Section 1 Submission on the Waterview Connection Proposal

This document forms the “attached information” part of Cycle Action Auckland's submission, as referred to on pages 6 and 7 of our submission form.

Connection to Waterview, Waterbank Crescent - Local Access Concern

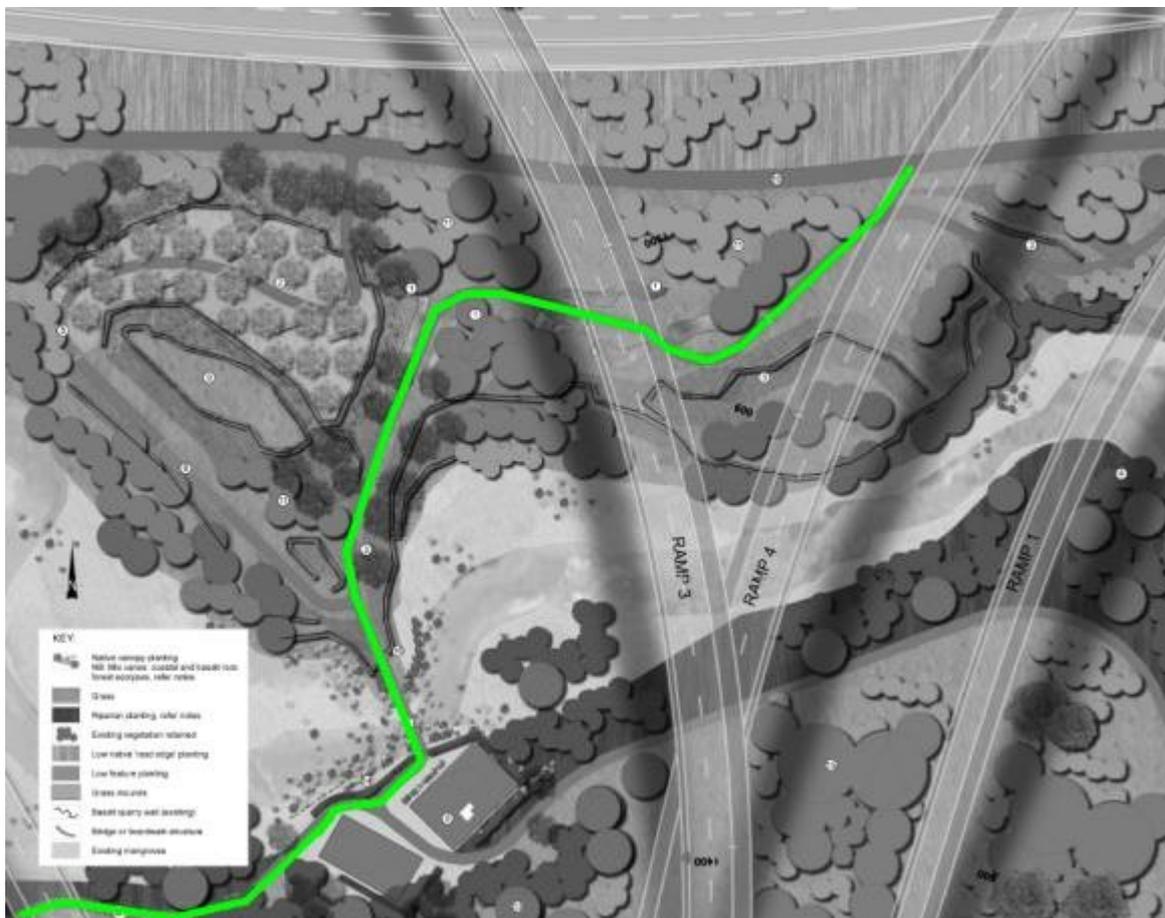
The concept for the Star Mill archaeological site underneath / to the southwest of the interchange proposes walking paths and bridge to link the cycleway with Waterbank Crescent (Waterview). However, the proposed paths are too narrow to allow cycling.

Cycle Action considers that these paths could easily be widened (to at least 2.0m width, preferably 2.5m or more) to create an off-road cycling access from the Waterview suburb to the SH16 cycleway. This does not only safely accommodate those cyclists which will use this path anyway (unless prevented by draconian measures like stairs and gates) but also, for little extra cost, improves the crucial Waterview / Pt Chevalier link by improving cycling access (cyclists can avoid the hostile Great North Road route).

Safety for pedestrians can be accommodated by ensuring that landscaping protects appropriate sightlines, as well as via small curve radii and chicanes to slow cyclist speeds on this minor path (chicanes should however not force cyclists to dismount).

For these reasons, we ask the Board of Inquiry to modify the proposal to create a cyclist-friendly side access between the cycleway and Waterbank Crescent, slightly upgrading the already proposed pedestrian path and bridge.

Section 4.8 Sector 8 - Avondale Heights Tunnel

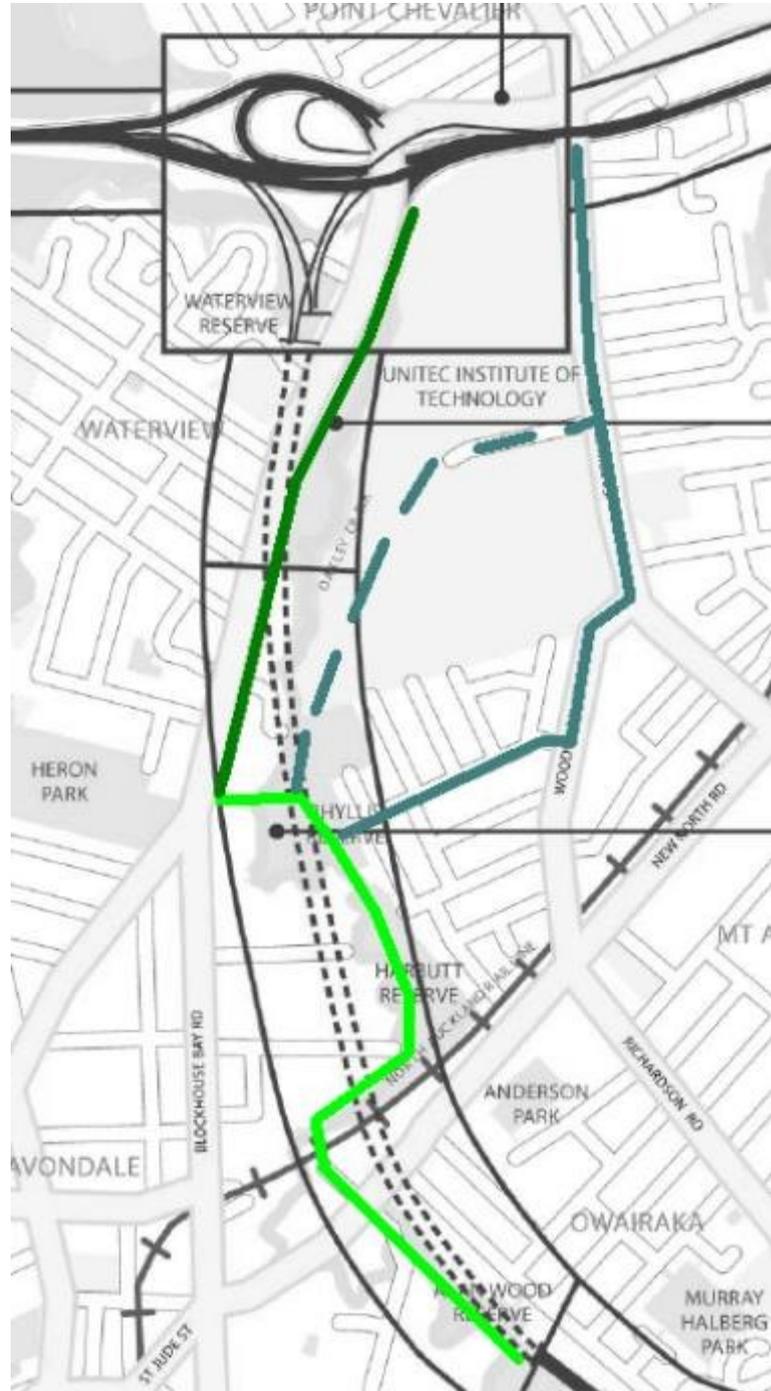
Our concern regarding the non-provision of a cycleway in this sector has already been discussed in Section 3.1. In this section of our submission, we therefore only provide a map showing potential / preferred routes for the “Sector 8 Cycleway” discussed there.

Southern route - all variants includes bridges over rail (likely at Soljak Place) and over Oakley Creek (likely at Phyllis Reserve) to provide west-east connectivity (and allow all catchments, west and east) to access SH16 and SH20 cycleways safely.

Northwestern route Off-road path along rebuilt Great North Road, linking into existing off-road path. Some concerns about side accesses / driveways across cycleway.

Northeastern route Partly on-road route using existing and improved on-road cycling facilities on Carrington Road, and possibly having access through Unitec if such a route is acceptable.

Our request to the Board of Inquiry is discussed in Section 3.1 of this submission.
